March 16, 2004

Brigid Kudzius  
Downtown Transportation Plan Implementation Team  
Vancouver City Hall  
453 West 12<sup>th</sup> Ave.  
Vancouver, BC V5Y 1V4

We are pleased to see quick progress in the development of a Hornby St. bike lane, and we are certainly eager to see a lane in place before the summer. However, we wish to ensure that the facility that is built is as safe and comfortable as possible for cyclists. After discussions with yourself and other staff at the recent open house, we have a number of specific requests regarding the upcoming bike lane:

Figure 1: Different options for addressing right-turn conflicts (not to scale).

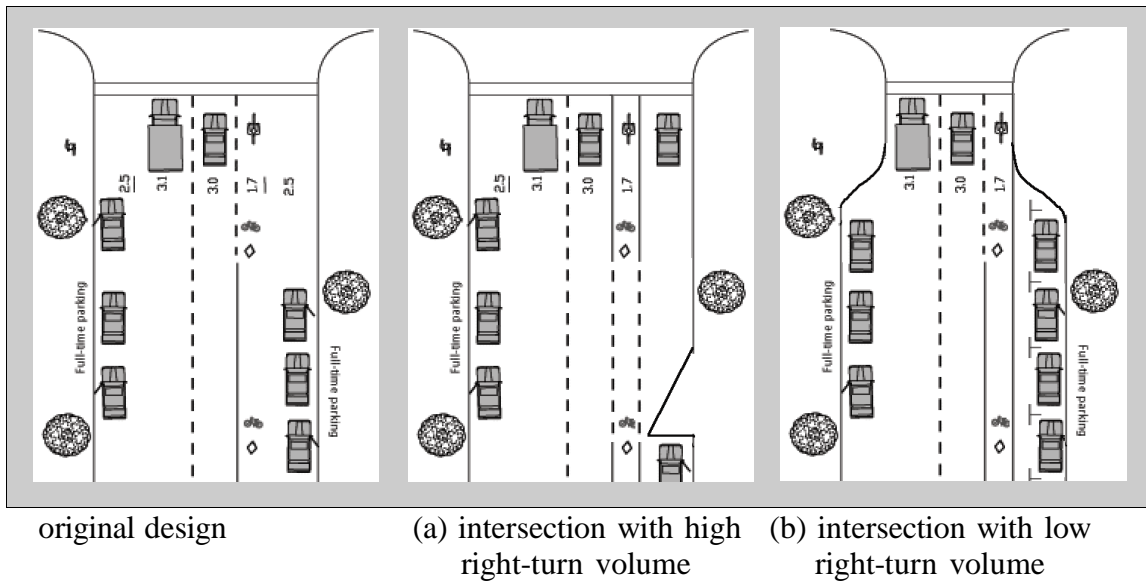
At both Nelson St. and Pender St., a better design is needed to cope with the high volume of right-turning vehicles. The design presented at the recent open house left only a small right-turn lane at the intersection, with no space for vehicles to queue in

preparation for making right turns. In this situation, the typical right-turning motorist will push their nose into the curb lane while they wait for space, blocking the bike lane completely. This is wasteful, since the motorist forces queuing in both the lane s/he is leaving and the bike lane. Furthermore, it gives right-turning vehicles priority over all cyclist traffic. Unlike motorists, most cyclists cannot safely use the leftmost “through” lane to bypass right-turning vehicles. Given the priorities established in the City's 1997 Transportation Plan (pedestrians, bicycles, transit and finally private automobiles), we believe a different design is required.

With the high right-turn volumes found at Nelson St. and Pender St., we do not believe that design (b) will be a reasonable solution. This approach will result in many motorist/bike conflicts at the intersection, and force a lot of vehicle queuing in the main through lane. At these streets, we prefer design (a). This design must include sufficient queuing space for the typical peak volume of right-turning vehicles, and should include a solid curb to separate parking from the right-turn lane (shown as a triangular shape in the diagram above). At other low-volume intersections, however, design (b) could be quite suitable.

Most other intersections along Hornby have low right-turn volumes, including Drake St., Davie St., Helmcken St. and Pender St. The remaining intersections permit no right turns at all, at Robson St., Smithe St. and Dunsmuir St. We suggest the use of design (b) at all of these intersections. This design would prevent motorists from using the narrow curb lane for right-turns in a space with insufficient queuing, reducing conflicts with cyclists. It is also the design originally planned for Hornby St. in the Downtown Transportation Plan, presumably to aid pedestrian crossings (spot

A better solution would be (a) to provide more queuing space in the curb lane by removing parking, or (b) to eliminate the curb lane (via a curb bulge) and force all queuing to occur in the main traffic lane, allowing cyclists to continue to the intersection, where they are more likely to be given a chance to obtain right-of-way.

Figure 2: Different options for intersection of Hornby and Hastings (not to scale).

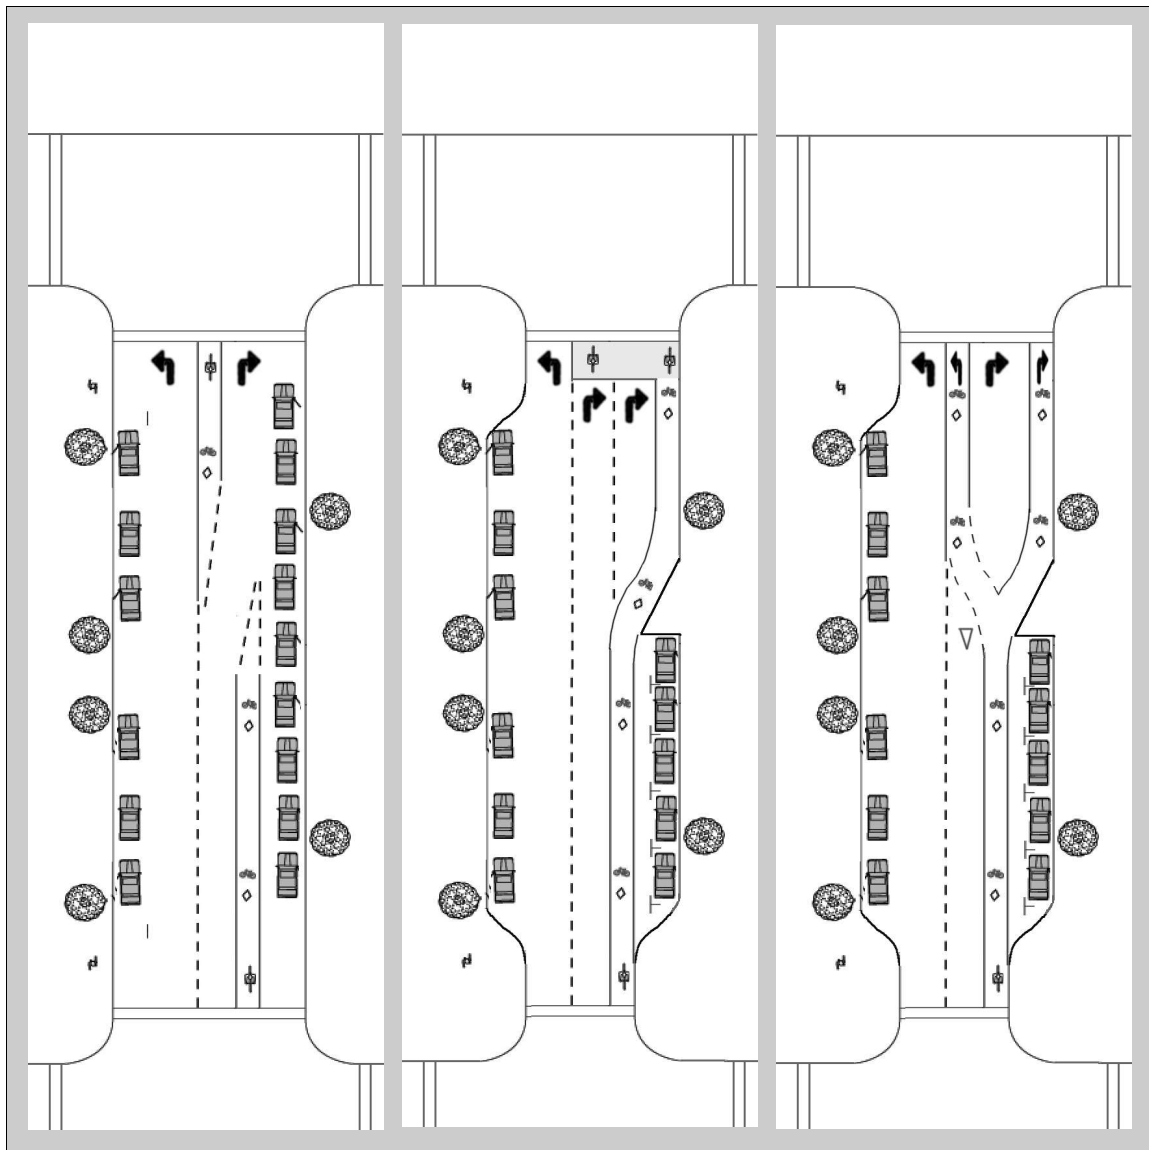
The difficulty of allowing cyclist left turns lies in shifting cyclists left of the right-turning vehicle traffic at Hastings. During the p.m. peak of a 2002 traffic count, Hastings St. recorded the highest vehicle right-turn volume of all of Hornby St. (450 vehicles in an hour) with its current configuration, which includes two right-turn lanes. From discussions at the open house, we understood one of two major changes was possible at the Hastings intersection: the addition of an “advance green” signal for cyclists, or the removal of a single right-turn lane. With this understanding, we propose two possible designs for the intersection, shown in Figure 2.

For the sake of comparison, the figure includes the interim design presented at the recent open house. We have two main problems with this design: it assumes that all cyclists are making left turns, and it makes these left turns both difficult and dangerous by granting motor vehicles right-of-way in a conflict region.

Design (b) is quite similar to the open house design, with simple corrections to eliminate the problems we saw in the design. It includes two bike lanes, one for left turns and one for right turns. It also includes a transition region giving left-turning cyclists clear right-of-way over right-turning vehicles.

The advantages of design (b) are: simple separation of cyclists into left- and right-turning streams; no changes to signals required; motor vehicles may still make right turns at red signal; probable reduction in right-turning vehicle traffic due to reduction to one right-turn lane. The disadvantages are: all motorists must yield to left-turning cyclists, which will slow traffic and will be difficult to enforce; shift to left-turn position is potentially quite dangerous; reduction in parking capacity; reduction in capacity for motor vehicle right-turns.

Our design (a) is based on a special “advance green” signal exclusively for the use of cyclists. In this concept, the signal at Pender St. is synchronized with the signal at Hastings St. to ensure that cyclists crossing Pender on a green signal and travelling at speeds of 10-20km/h will arrive at Hastings during the red signal phase. At the intersection, a bike box allows cyclists to shift left for a left turn or stay in position for a right turn. Motorist right turns are prohibited during the red phase, to avoid conflicts in the bike box region. Next, a special signal gives cyclists a green while still prohibiting right turns for motorists. This phase can be brief; most cyclists will be in the bike box already, prepared for their turns. Finally, the signal switches to a regular green phase, allowing motorists to make their right turns. The three key elements of this design are the advance green signal; the bike box (which allows many cyclists to turn simultaneously instead of requiring a long signal phase to allow all cyclists to clear the intersection); and the prohibition of motorist right turns during the red signal phase.

The benefits of design (a) are: highest safety, with no conflicts between vehicles and cyclists; simple, common solution for both left- and right-turning cyclists; conventional arrangement of bike lanes on street; larger motor vehicle right-turn capacity, with two

lanes. The disadvantages of this approach are: reduced parking capacity; driver education needed with novel signal system; synchronization required with Pender St. signal; no motor vehicle right turns on red. One potential modification of this design would be to substitute parking instead of a second motor vehicle right-turn lane, trading off right-turn volume for parking capacity.

Based on the pros and cons discussed here, we have a strong preference for design (a) at Hastings St. This design is the safest solution we have seen, while still allowing a reasonable volume of cyclists to make left- and right-hand turns. Of all the designs presented to date, this has the most potential to appeal to both confident commuter cyclists and novices. If this design is selected for implementation, we believe that it must include all of the key elements to succeed: an advance signal for cyclists, a bike box, and a prohibition of right turns on red. Design (b) is a distant second choice, but would also be acceptable provided that left-turning cyclists are guaranteed right-of-way over right-turning motorists. We do not consider the interim design presented at the open house to be acceptable.
